REMARKS

The present Amendment amends claims 1-8, 10-15, 17-20, 22 and 24 and leaves claims 9, 16, 21, 23, 25 and 26 unchanged. Therefore, the present application has pending claims 1-26.

FSTr FRAME COUNTER SWEEP PATTERN MEMORY FIG. 19 Pur ANT CK—CK OUTPUT SWEEP CALCULATOR l'sg R'sg ST SYNC DETECTOR & CORRELATOR ST **NULL END DETECTOR** SWEEP START COMMAND PULSE 쏬 쏫

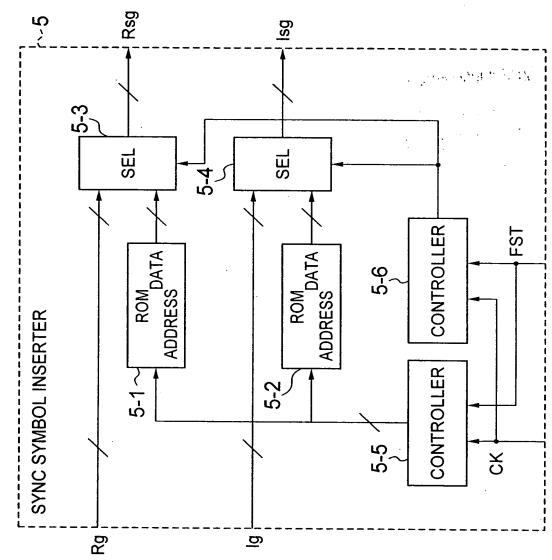
In paragraph 2 of the Office Action the Examiner objected to Figs. 17-26 as not having the legend "Prior Art". Filed on even date herewith are Proposed Drawing Corrections adding the legend "Prior Art" to Figs. 17-26. Therefore, this objection is overcome and should be withdrawn.
